## ADDENDUM # 03

Hartsville Middle School  
Auditorium HVAC - Upgrades  
DARLINGTON COUNTY SCHOOL DISTRICT  
JCS PROJECT NO: 22011-A  
September 27, 2022

SHEET NO: M103

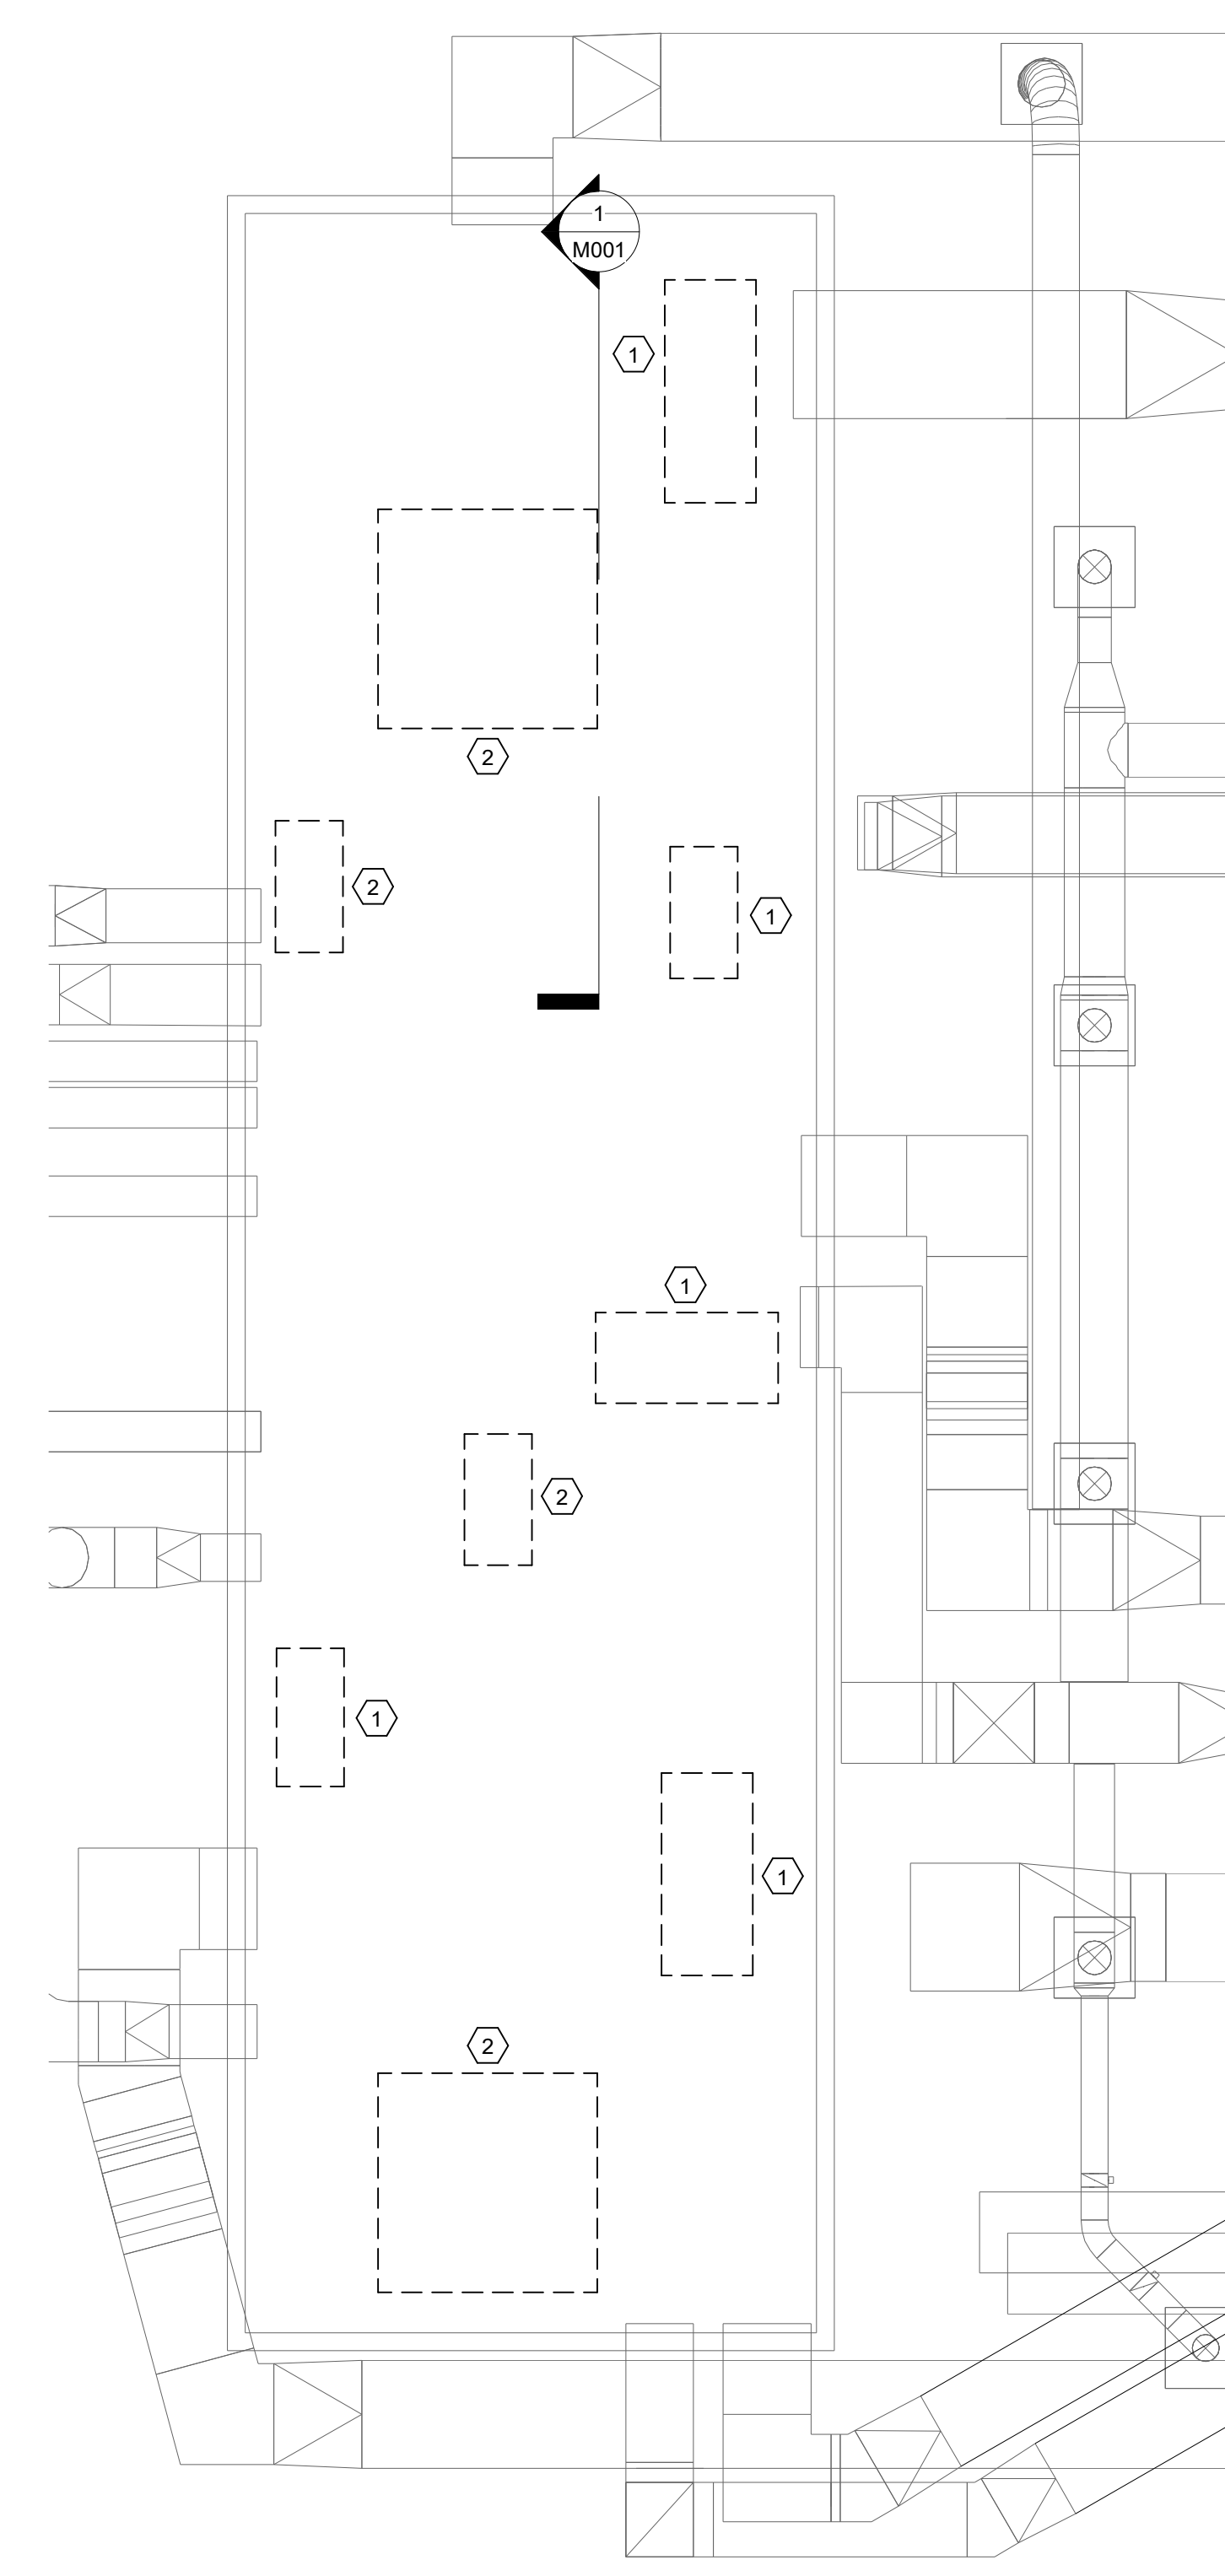
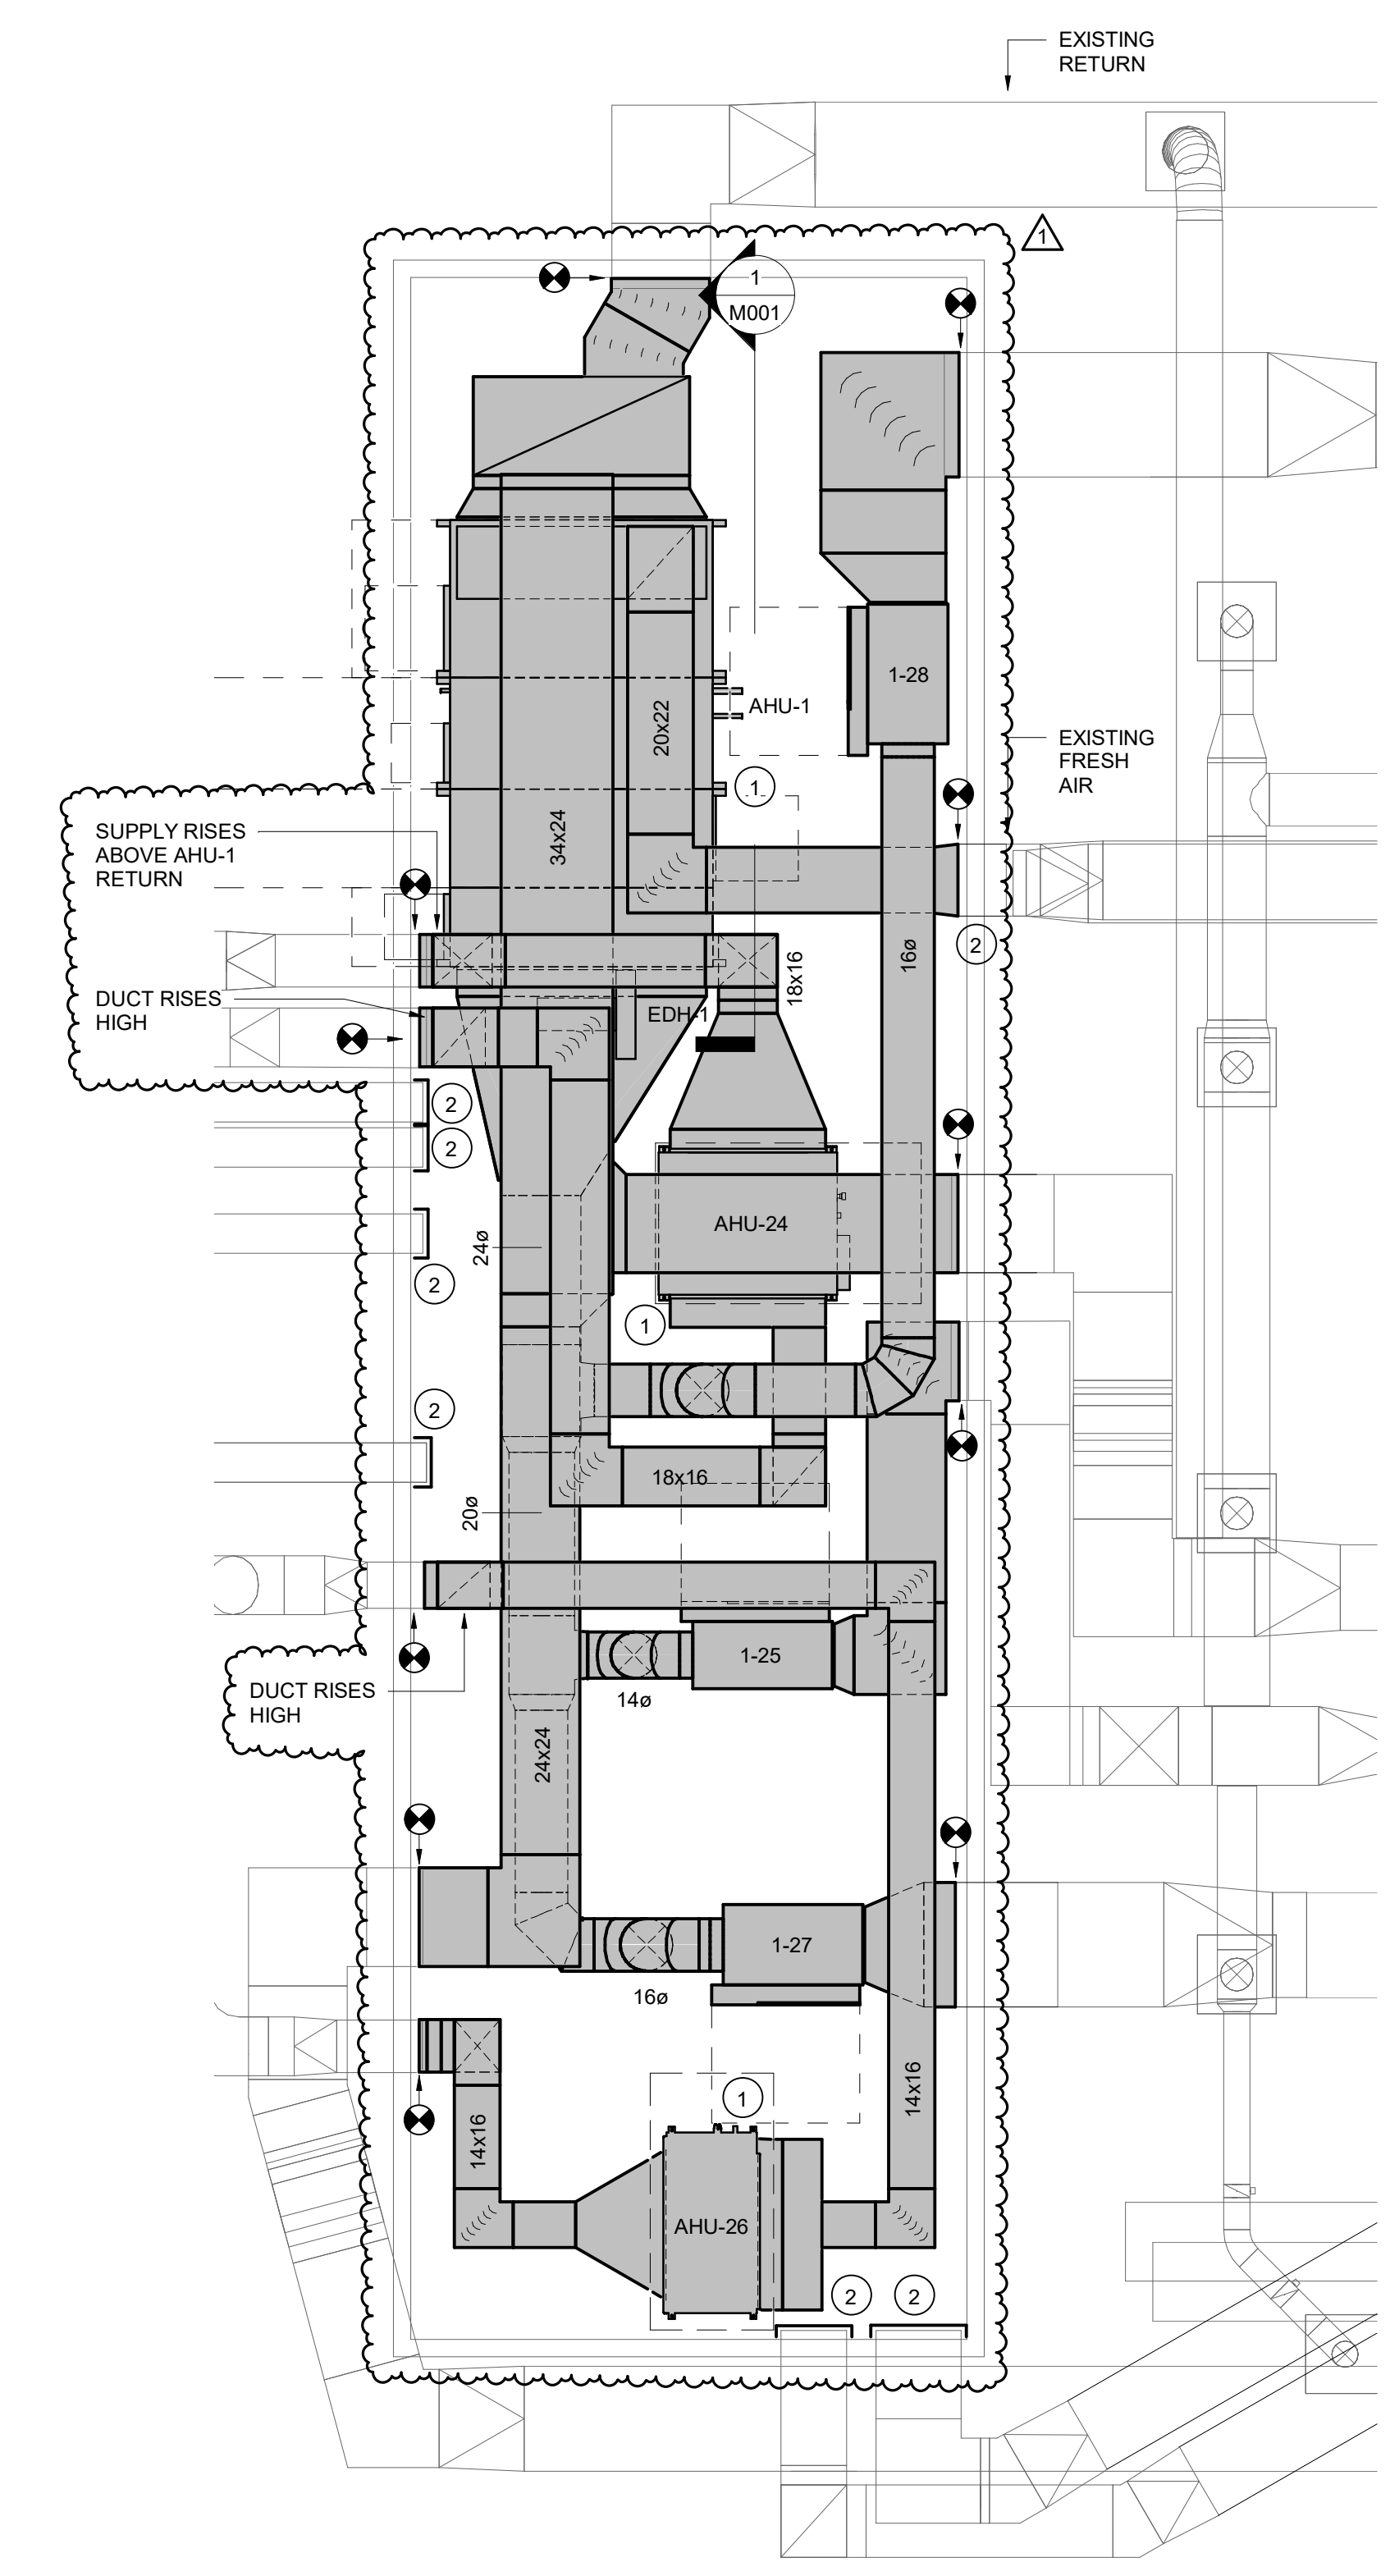
See the attached revised drawings: M-001; M-102; and M-103. Changes are bubbled.
